## REMARKS

The examiner has objected to claims 1, 3, 9-10, 13, 15, 22, 24, 27, 29-33 and 38 because of noted informalities. Applicant is amending the claims to correct these informalities.

Figure 1. Cable System - Prior Art

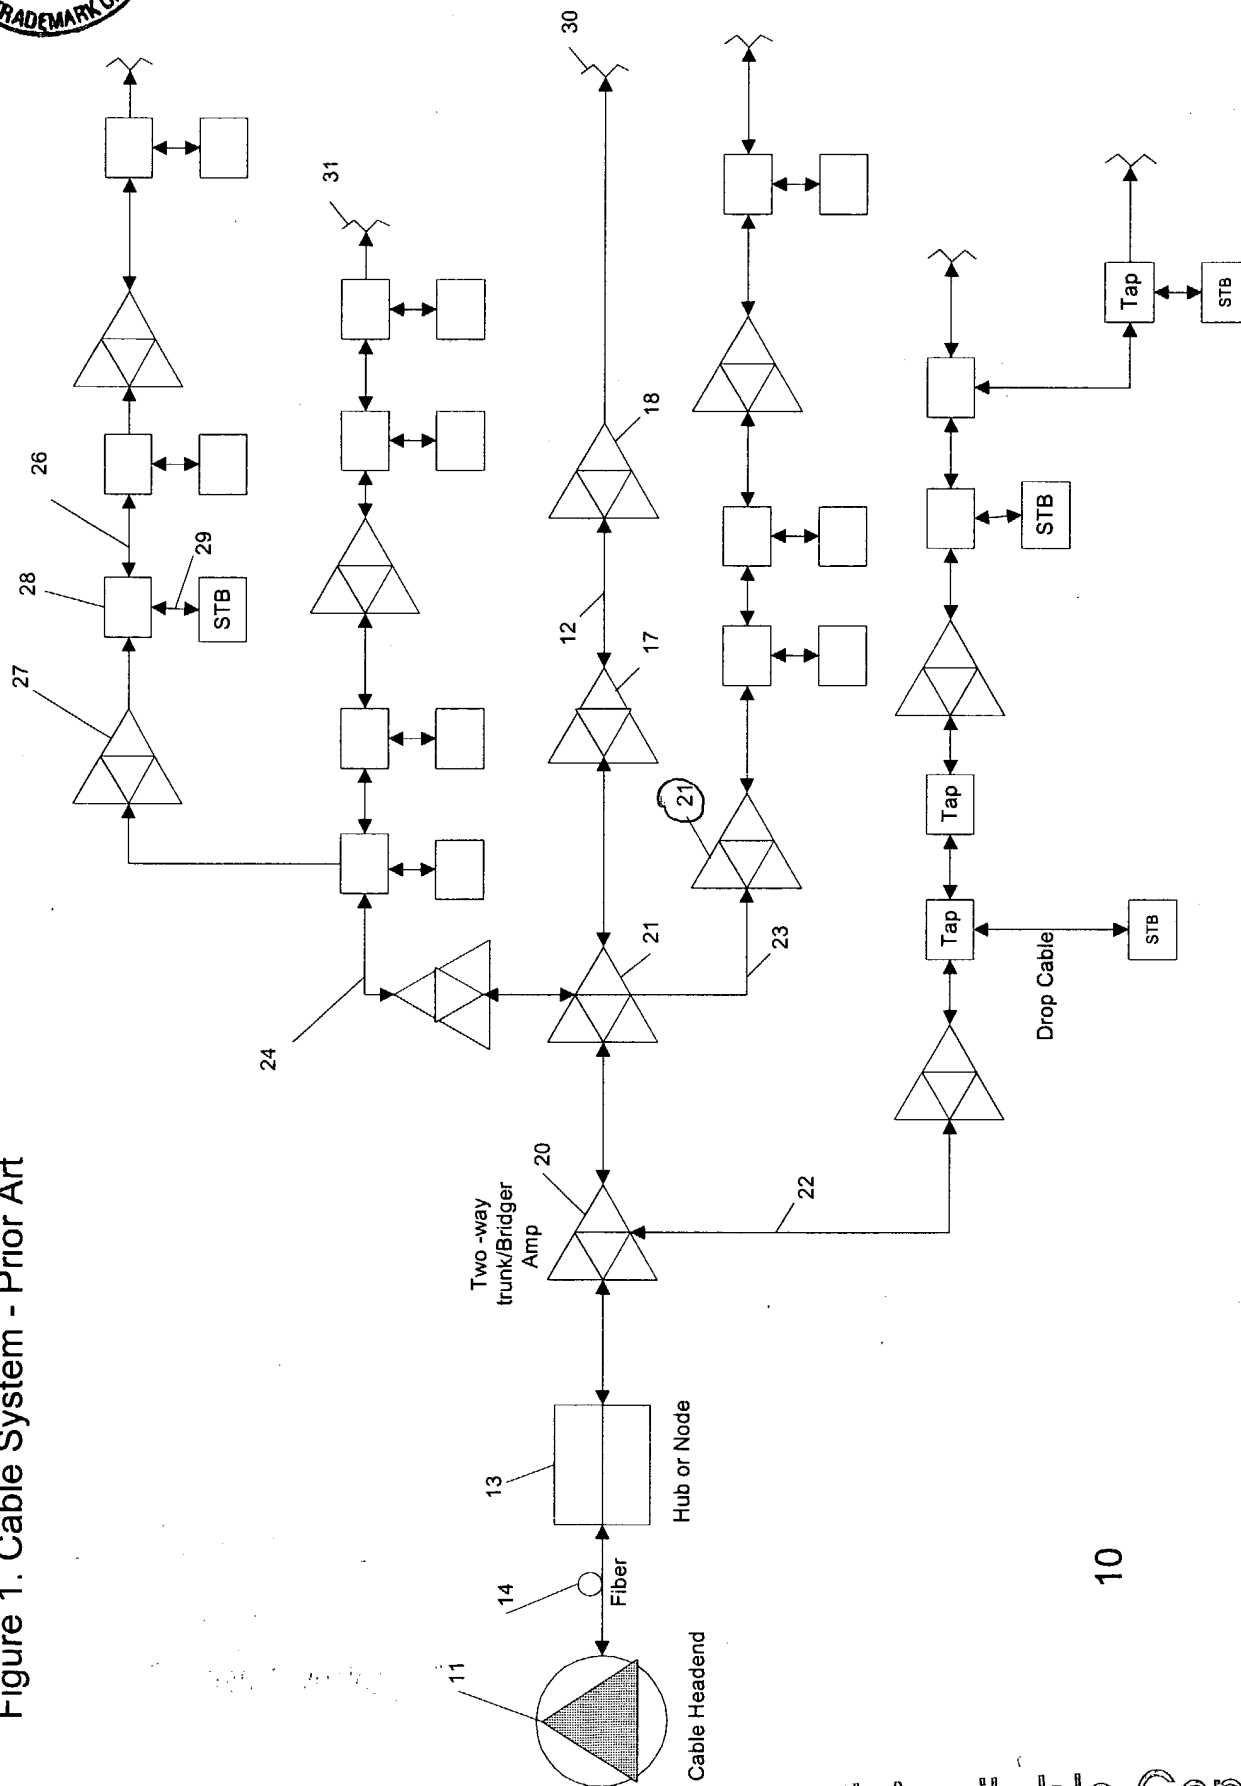
The drawings are being corrected and submitted herewith as directed by the examiner.

MARKED UP
